# GCCF PUD Zoning Map Amendment

CITY OF VENICE

Planning and Zoning Division Staff Report

**Petition Number:** 18-10RZ

MAP A: Planned Unit Development Binding Master Plan (depicting layout)

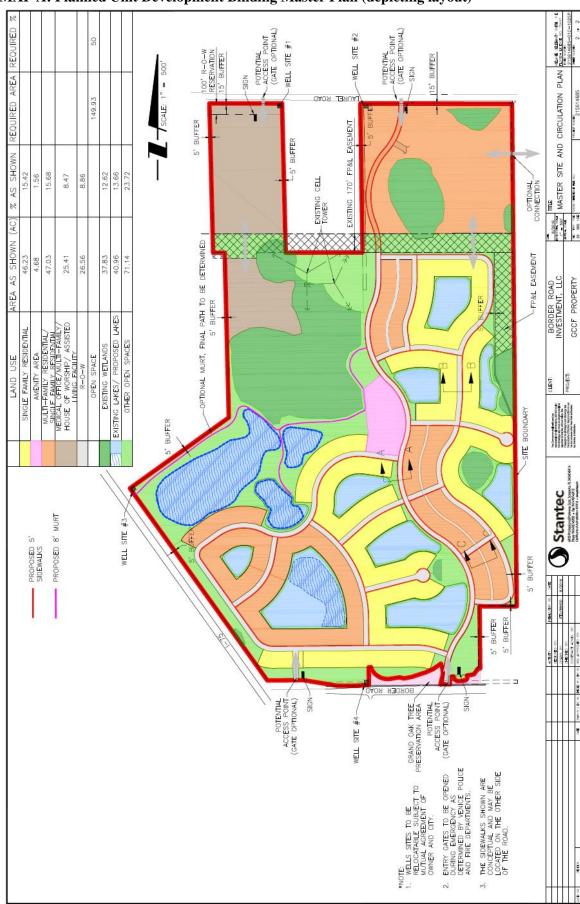
**Staff comment:** Generally (upon review of the PUD Binding Master Plan (depicting layout) – see Map A), it is noted that the proposed development as a PUD and the requirement for 50% open space affords opportunity to provide for a compact development pattern which allows for preservation of the open space and protection of environmental resources while maintaining wildlife corridors. The PUD zoning district is an appropriate designation for the subject property.

**Staff Comment:** The binding master plan layout provides a depiction of the proposed uses and location thereof.

The applicant has indicated "Gate Optional" at each end of the main north/south connector road from Laurel Road to Border Road. Although this is consistent with the indications of Strategy TR-NE 1.1.4, staff has concerns regarding the main north/south connector road through the proposed development being gated. This proposed roadway is in close proximity to the intersection of Laurel Road, Knights Trail, Interstate 75 and Pinebrook Road to the west. Having this road open and available for public use will provide an alternative to I-75 between Laurel and Border Roads and will allow for greater dispersion of local traffic. This would be a beneficial option if there is a traffic issue in the surrounding area, especially with the Interstate and could relieve stress on the overall transportation system. Availability of this roadway could also minimize necessary improvements to the transportation system as a whole. As a result, a stipulation is provided in the above analysis of the GCCF PUD to remove the gating option and provide opportunity for public access.
